**From:** Ted Harberg <tharberg@broomfield.org>  
**Sent:** Friday, October 25, 2024 11:00 AM  
**To:** Development Referral  
**Subject:** Fwd: 1st Referral Review - ZON2024-00003 I-25 Erie Gateway South PD  
**Attachments:** [2024Development Referral Card - Final.pdf](#)

**From:** Doug Trettin <[dtrettin@erieco.gov](mailto:dtrettin@erieco.gov)>  
**Date:** Wed, Oct 23, 2024 at 5:19 PM  
**Subject:** 1st Referral Review - ZON2024-00003 I-25 Erie Gateway South PD  
**To:** Patrick Hammer <[phammer@erieco.gov](mailto:phammer@erieco.gov)>, Kendra Carberry <[klc@hpwclaw.com](mailto:klc@hpwclaw.com)>, Austin Pierce Flanagan <[apflanagan@hpwclaw.com](mailto:apflanagan@hpwclaw.com)>, Lee Mathis <[lmathis@erieco.gov](mailto:lmathis@erieco.gov)>, Mike Haefele <[mhaefe@erieco.gov](mailto:mhaefe@erieco.gov)>, [prevention@mvfpd.org](mailto:prevention@mvfpd.org) <[prevention@mvfpd.org](mailto:prevention@mvfpd.org)>, Doug Saba <[dsaba@mvfpd.org](mailto:dsaba@mvfpd.org)>, [haddad\\_don@svvsd.org](mailto:haddad_don@svvsd.org) <[haddad\\_don@svvsd.org](mailto:haddad_don@svvsd.org)>,

Erie Colorado  
Planning Department  
PD Zoning, ZON2024-00003  
Erie I-25 Gateway South

FIGURE  
D6

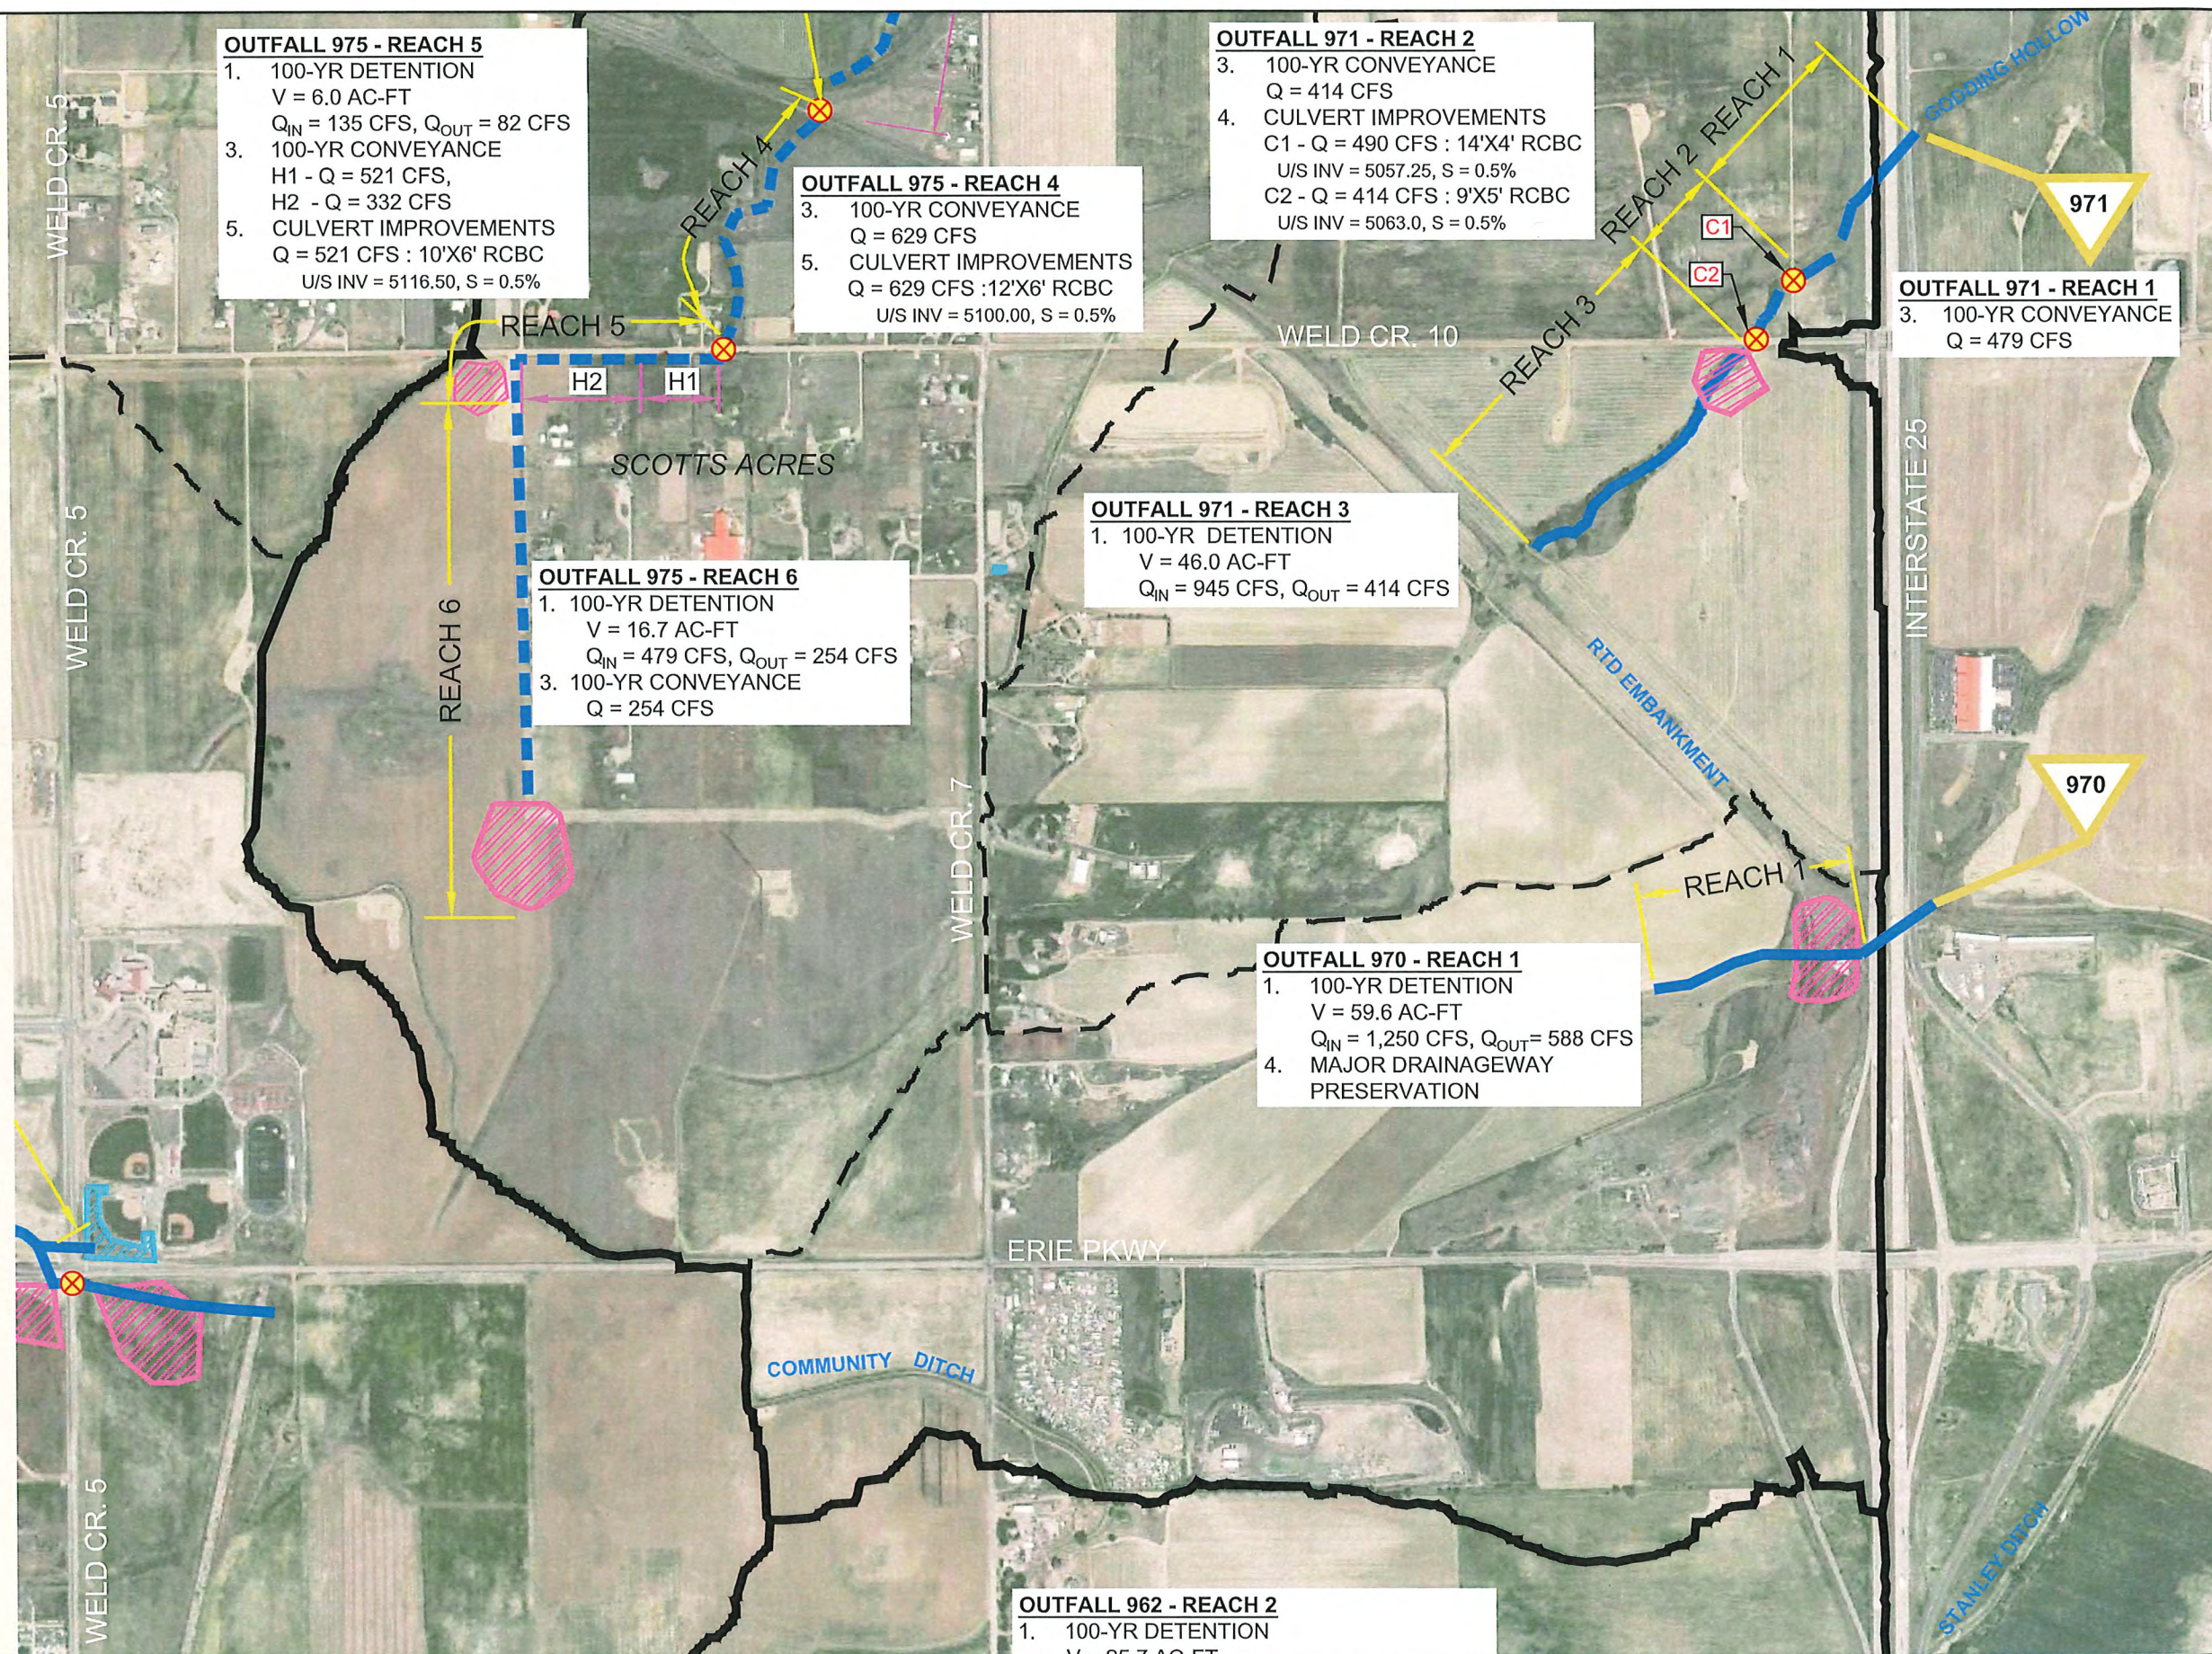
The City would like confirmation from Erie staff that the developer will implement the recommended improvements, with regards to Outfalls 970 & 971, from the East Cole Creek Outfall Systems Plan adopted by the Town of Erie in January 2020.

I've attached relevant portions of this plan for your reference, which detail the necessary improvements for these outfalls and their associated reaches when development occurs along Godding Hollow.

The recommended plan for this reach is to provide an improved channel along the drainageway from I-25 southwest to a dirt access road. Regrading the slope of the drainageway is required to connect the existing double 14'x6' RCBC across I-25 to the proposed culverts in Reach 2 (see below). The existing double 14'x6' RCBC across I-25 have adequate capacity to convey the developed 100-year flow northeast to the outfall. Even though this culvert has sufficient capacity, 100-year detention storage will still be required for future development.

The recommended plan for this reach is to provide an improved channel from a dirt access road southwest to WCR 10. A 14'x4' RCBC is proposed to replace the existing 36" RCP culvert across the dirt road to convey the 100-year storm event to Reach 1. A 9'x5' RCBC is proposed to replace the existing 36" RCP culvert across WCR 10 to convey the 100-year storm event.

The recommended plan for this reach is to preserve and stabilize the major drainageway from WCR 10 southwest to the RTD embankment. The recommended plan also includes a 46.0 acre-feet 100-year detention pond to reduce the developed condition runoff at WCR 10 from 945 cfs to the existing flow of 414 cfs.

Reach 1 for Outfall 970 is located north of Erie Parkway and west of I-25. The recommended plan for this reach is to preserve and stabilize the major drainageway and provide 100-year detention to reduce the developed condition flows at the outfall to existing rates. The 100-year detention has 59.6 acre-feet of storage volume and

Figure 6-1 Street Network Plan

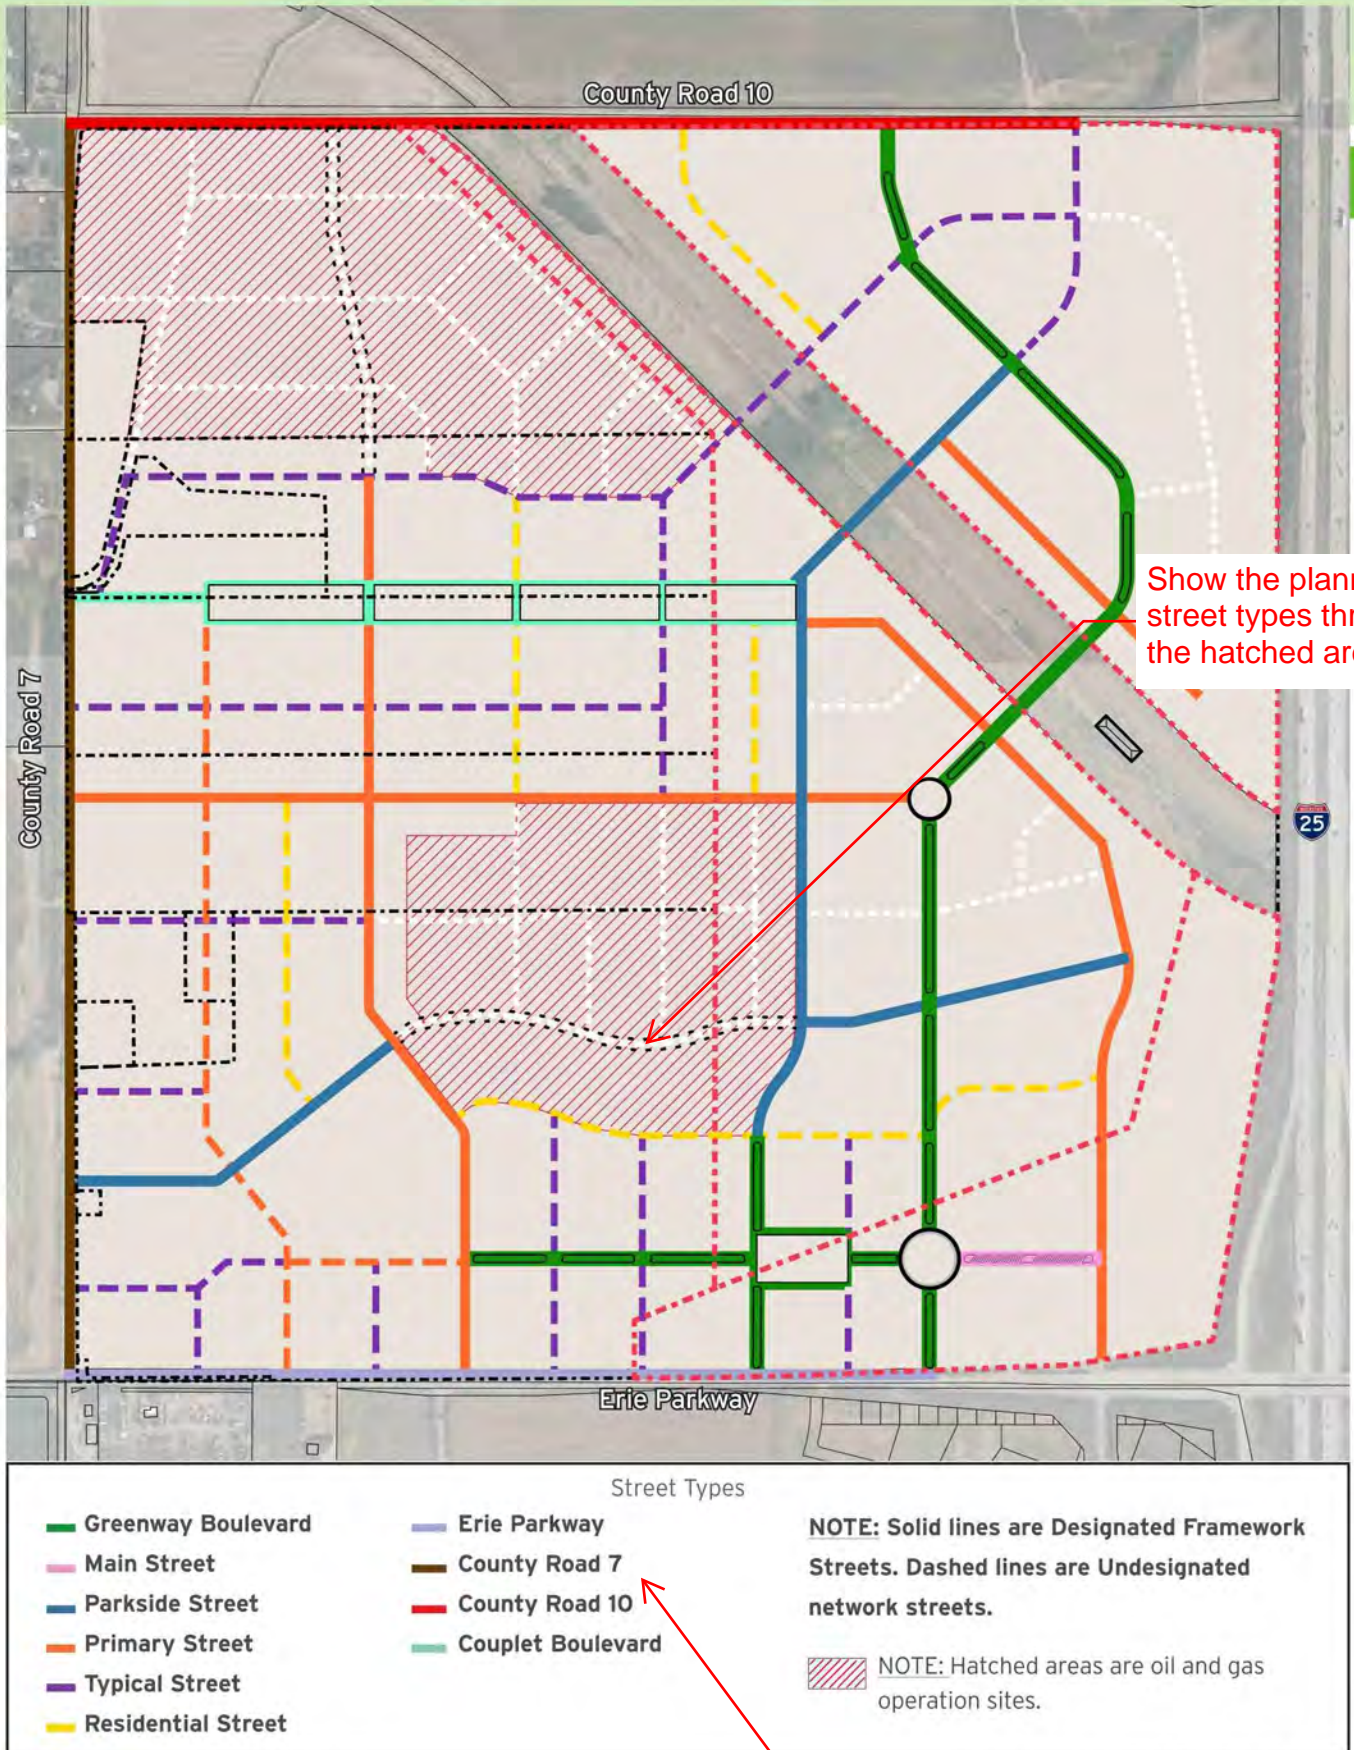
Not sure if we want to reference the TMP for pedestrian crossings/underpasses on this plan or the trail corridor plan. We also made note of it on the trail plan.

Figure 6-5 Primary Street Illustrative Plan and Section

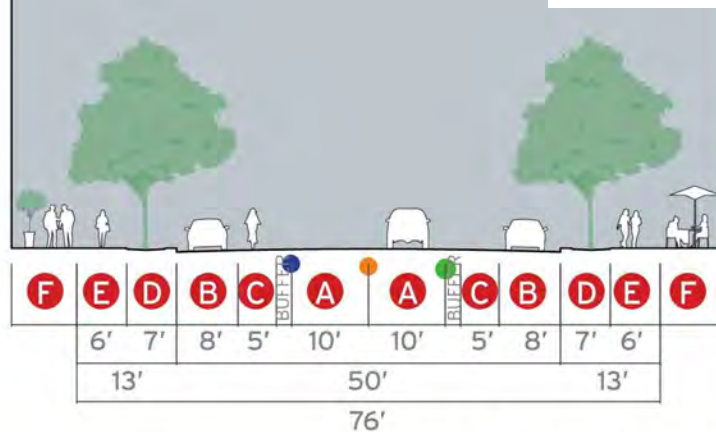
Does the entire length of this street type have tree grates, or only the commercial centers? May need to note that and indicate min. 8' wide tree lawns in non-tree grate areas.

Figure 8-3 Civic and Public Space Network Plan

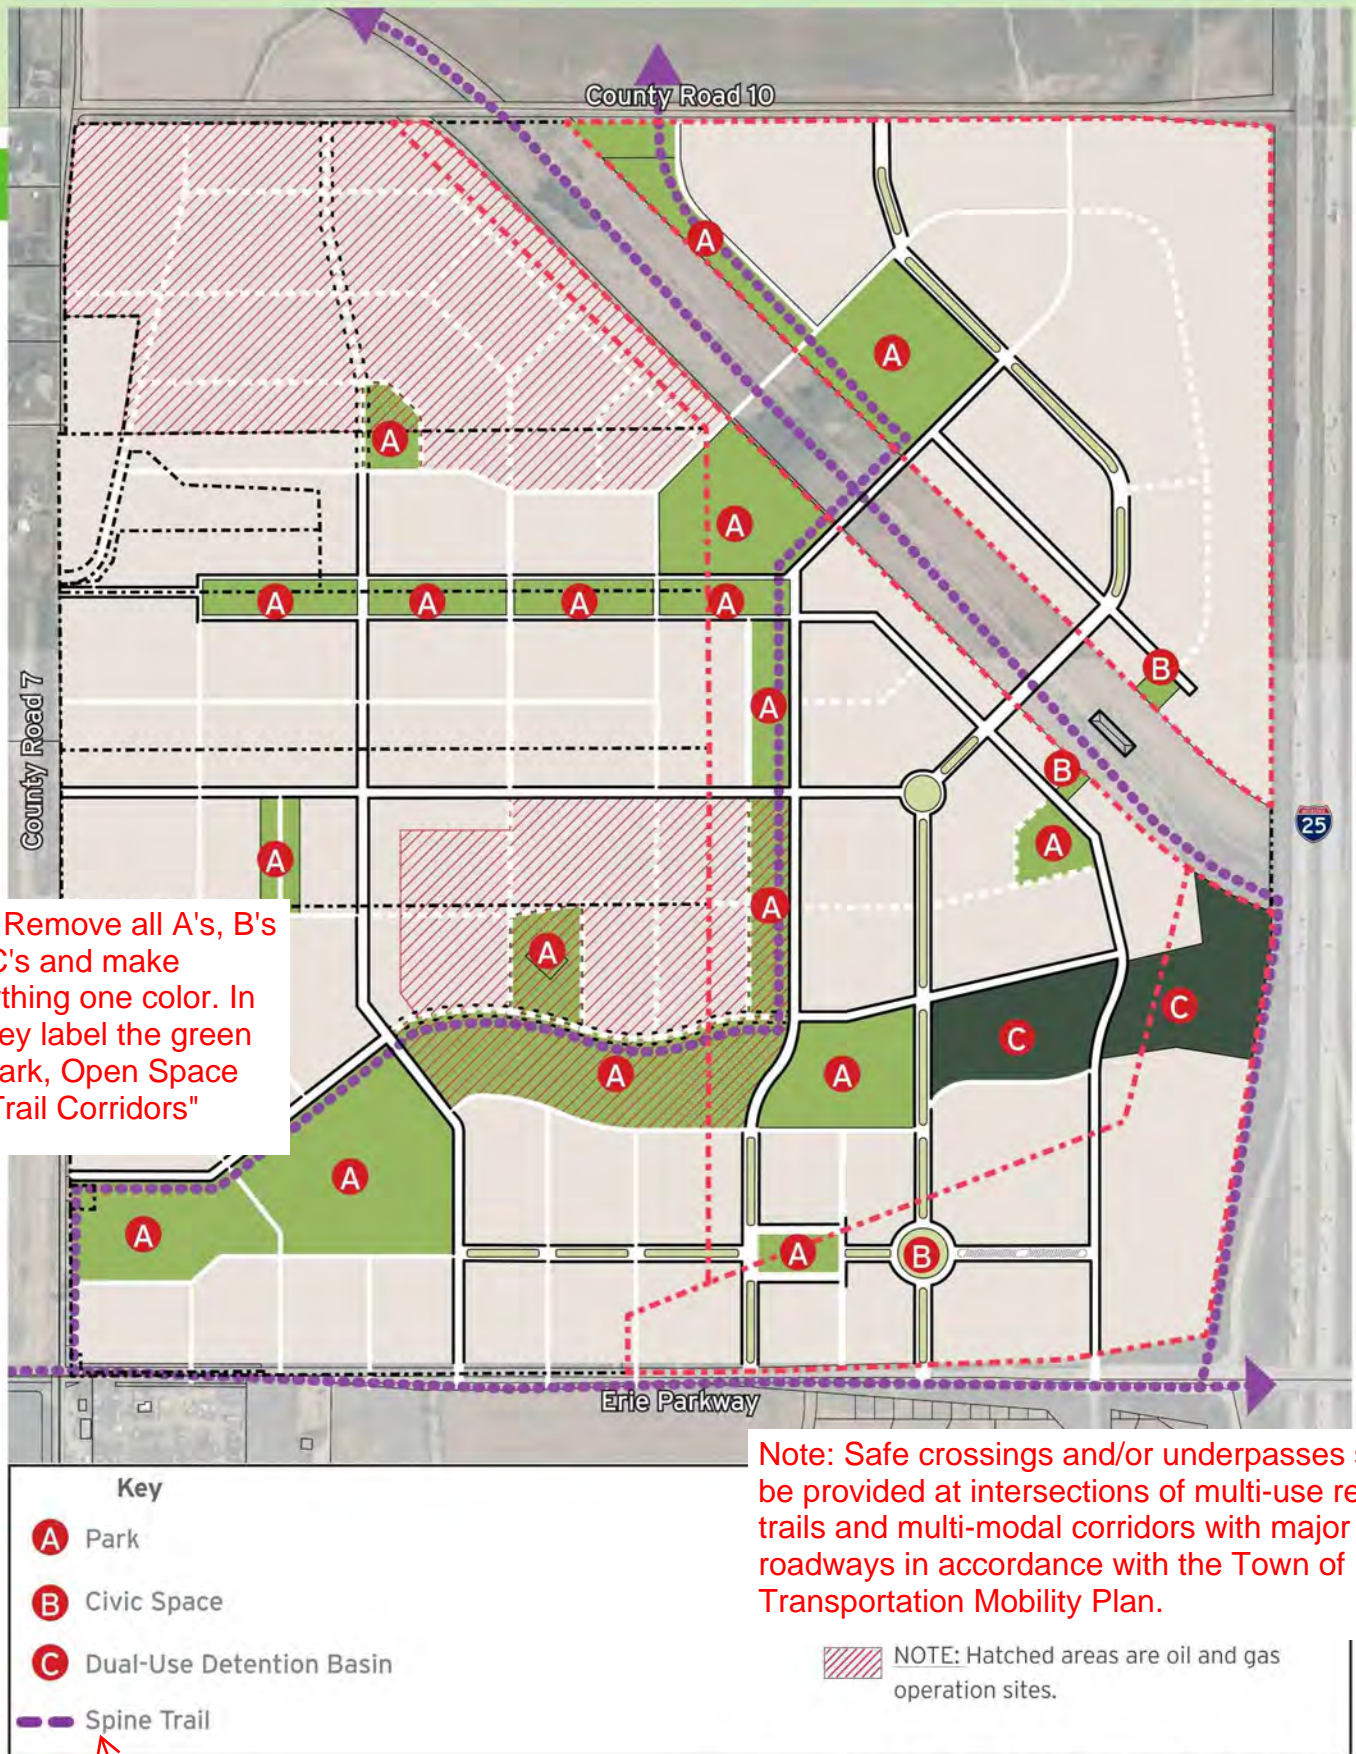
Suggestion for this section: "Figure 8-3 shall guide the locations of civic and public spaces as well as parks, open space and trail corridors. The Town of Erie Mixed-Use Development Parks & Open Space Vision Guide and/or the Unified Development Code (UDC) will be utilized to determine quantity, type, character and requirements of the Town's park and open space dedication requirements. The Parks, Recreation, Open Space and Trails Plan (PROST) will also be used as a guide for parks and open space as well as trail connectivity."

Map: Remove all A's, B's and C's and make everything one color. In the Key label the green as "Park, Open Space and Trail Corridors"
